Title: **ISA Turn-on Hangup**
Bulletin #: ISA0001 Issue Date: April 4, 2002
Models Affected: ISA 750, 800T, 450, & 500T
Bulletin Revision: A
Production Range: 01/2000–04/2002 (serial # 0100xxxxx–0402xxxxx)

Figure 2. Prop the channel module assembly up on the chassis standoffs.

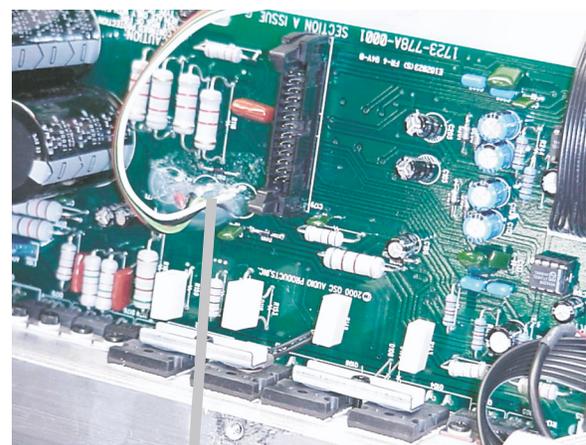
5. Lift up the front of the channel module assembly. Rotate it so that channel 1's module (the lower one) is on top; set the assembly down in the chassis with the heat sink resting on the standoffs (Figure 2).
